PC2S44G/B PH2S44G/C-42

File no 503-51	Date 23 AUG,2002	Scale 1/1	Unit mm	Rev. V30	Drawing
Dwg.no 503-51	Buyer SBG	TITLE: 2.5" to 3.5" HDD Adapter			
Drawn by	Checked by	Approve by	Buyer CFM.		
				ON-TECH ELECTRONIC FACTORY(CHINA)

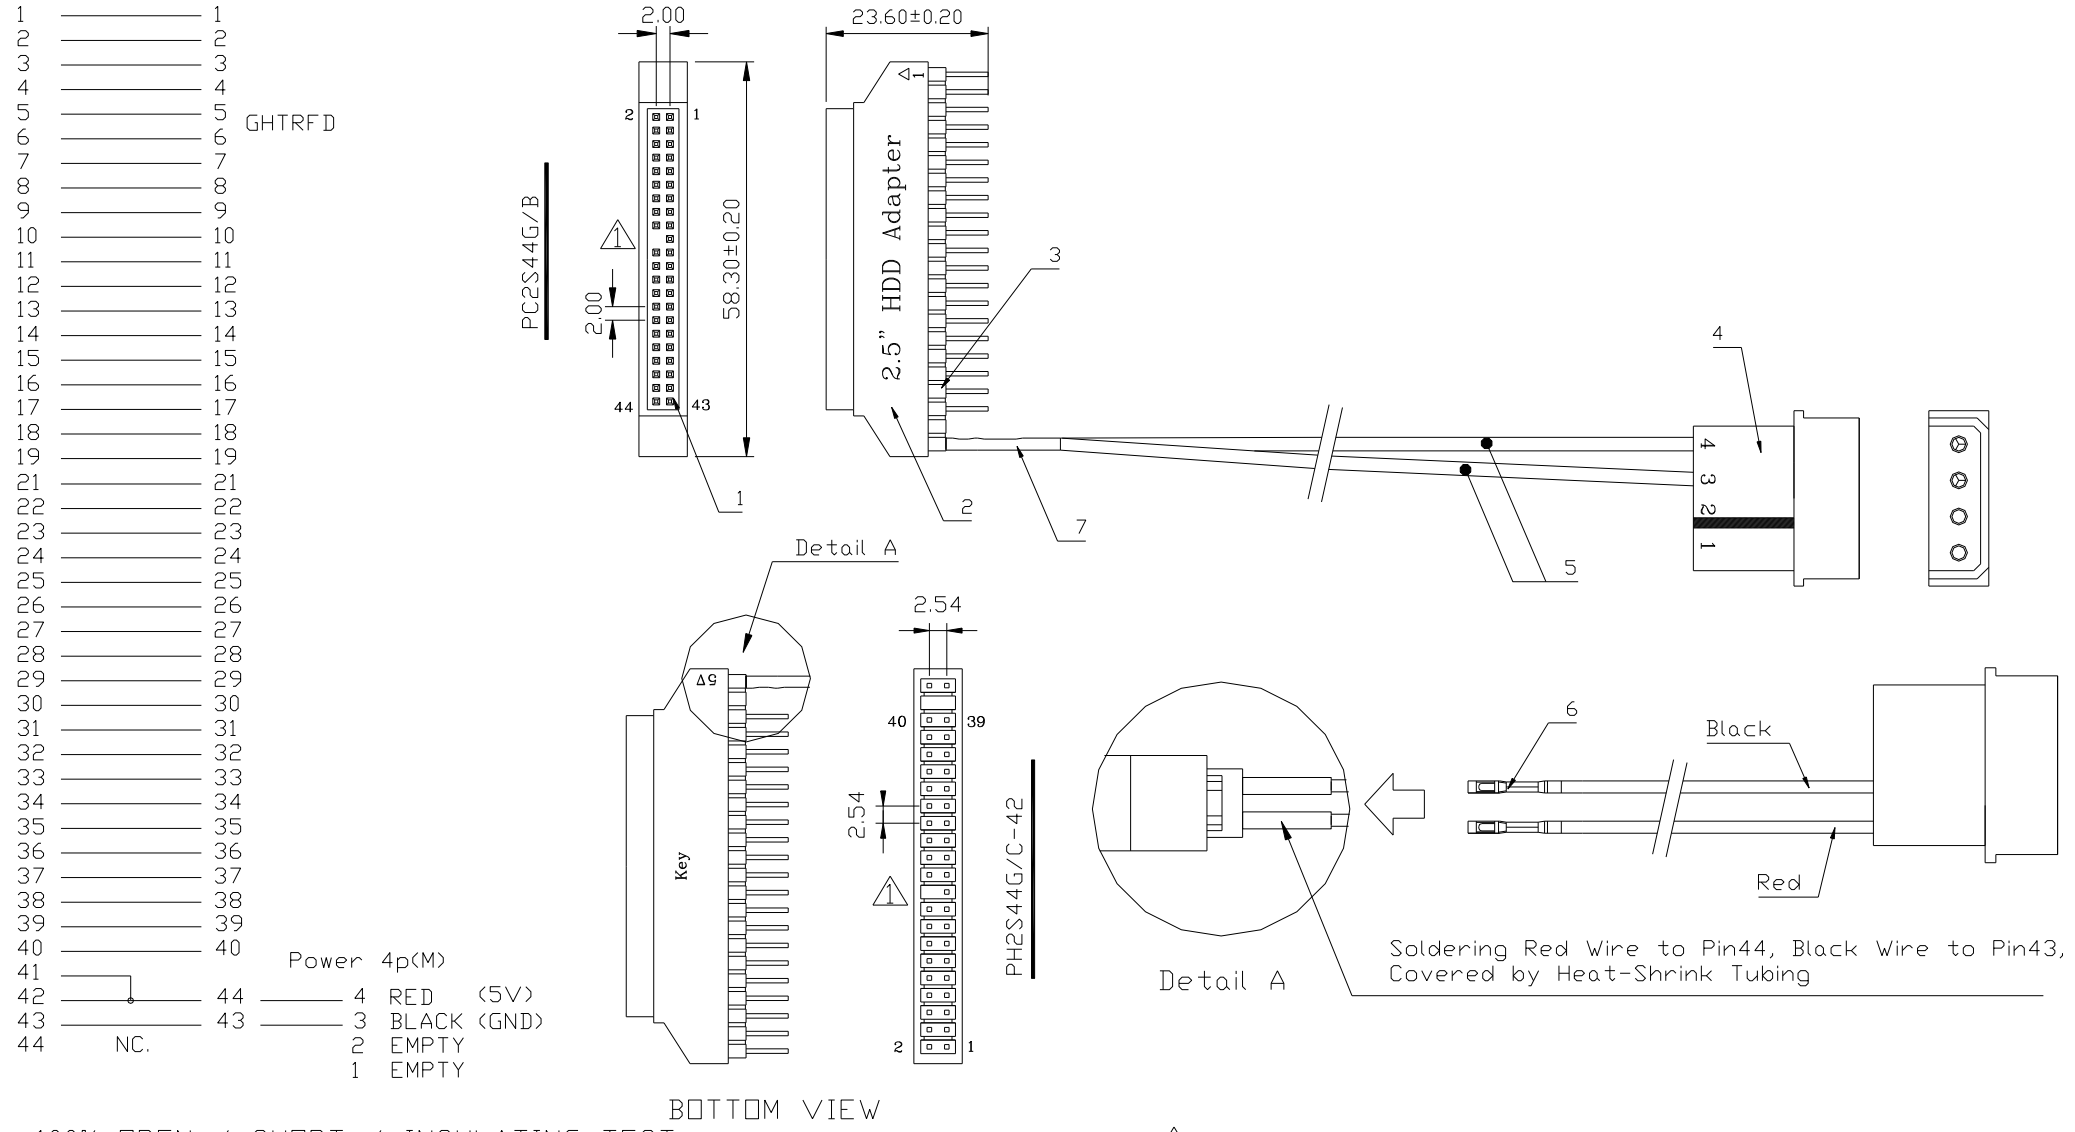
⚠1 MODLIFY:IDC FEMALE CLOSED THE 20TH PIN
IDC MALE MISSING THE 20TH PIN, 23 8,2002
